**PLAN COMMISSION**  
**August 15, 2013**  
**Village Hall**  
**125 Depot Street**  
**5:30 p.m.**

AMY HUDSON – VET CLINIC  
SITE PLAN

Re: Site Plan Review for Veterinary Clinic, Lot 08, Wright Road

Re: Wright Road Veterinary Clinic  
Site Plan Review  
MSA PN 05114017

Back Elevation  
 Scale: 1/16" = 1'-0"  
 07/31/13

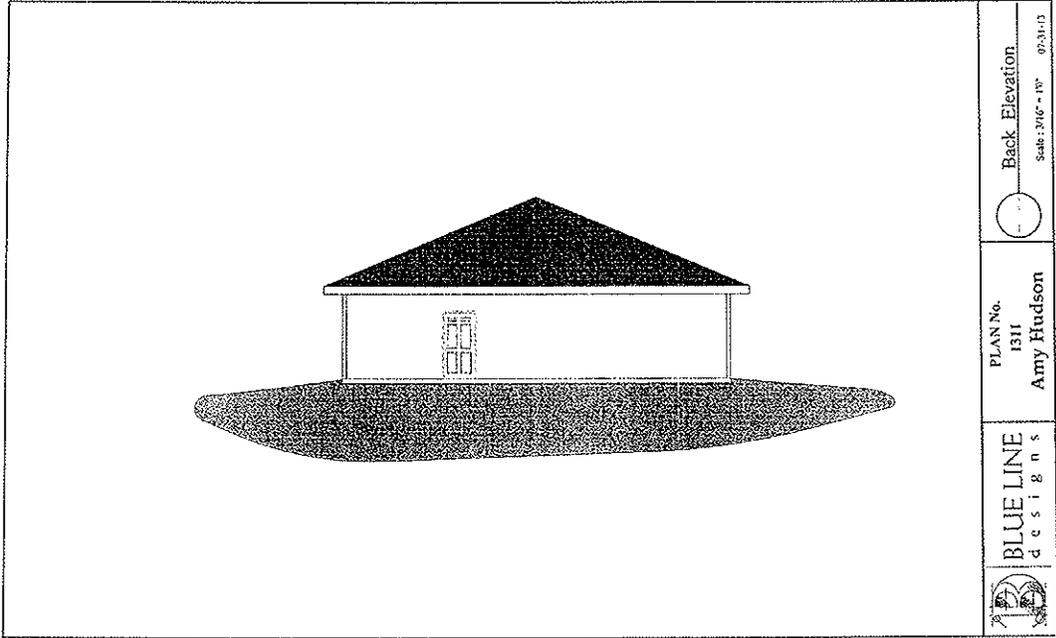
The exterior appearance of the proposed structure is not inconsistent with surrounding uses and does not present an incompatible development within this area of the Village. The front façade of the proposed structure provides an enhanced level of detail with coordinating materials and colors. In addition, the front entryway is pronounced with an overhang and architectural columns. Windows and/or doors have been incorporated on all sides of the structure, as appropriate for the internal uses shown on the floor plan.
